SERVICE BULLETIN

Classification: EC14-005	Reference: NTB14-103	Date: November 4, 2014
------------------------------------	--------------------------------	----------------------------------

2013-2014 FRONTIER; FUEL TANK HARD TO FILL

APPLIED VEHICLE: 2013 – 2014 Frontier (D40)
Shortbed Crew Cab vehicles **only**

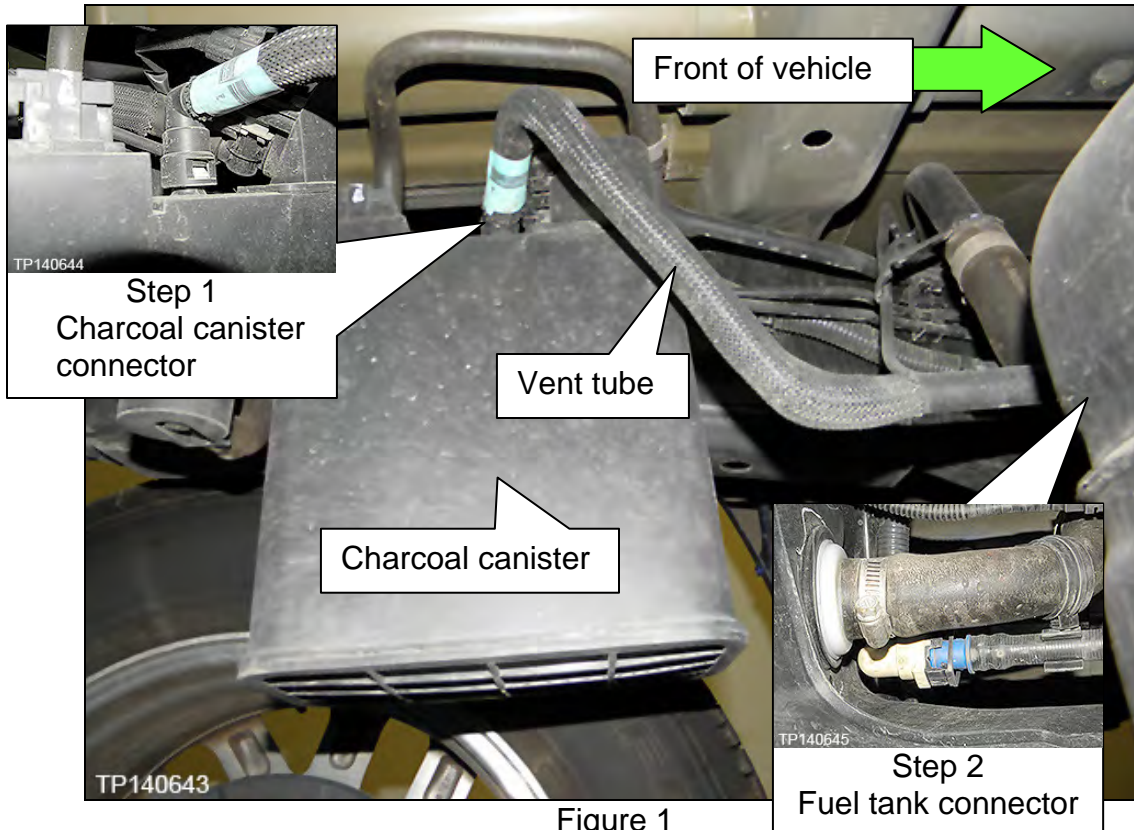
1. Disconnect vent hose at canister.

NOTE: See Figure A and Figure B for detail of "Quick connector" retainer release.

2. Disconnect vent hose from fuel tank.
3. Install new vent hose.
